SERVICE BULLETIN

Subject: GS Setting Table Chain Gear

Bulletin No. SB10-9

Figure 1

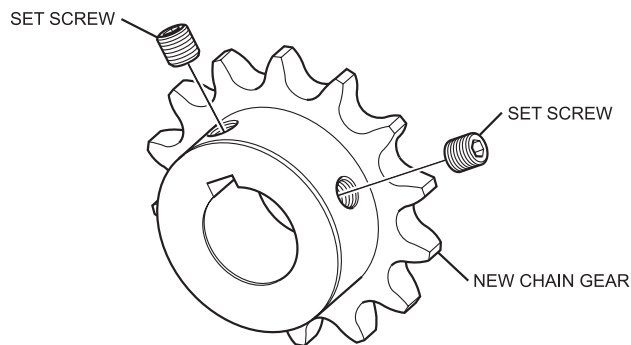
Based on feedback from our customers and distributors, we have added locations for two set screws on the setting table chain gears. Refer to *Figure 1*. We are also making the metric key that fits between the shaft and the sprocket, available from our service parts inventory. The previous version of setting table chain gears did not have set screws. This resulted in some issues with stress areas between the sprocket, the key, and the shaft.

The new part number for the setting table chain gear with set screws is 47-075474-009. Additionally, the part number for the newly available metric key is 11-053503-000.

i **NOTE:** *All existing inventory of the old part number, 47-075474-004, has been made obsolete and the new number, 47-075474-009, should be referenced when ordering this part.*
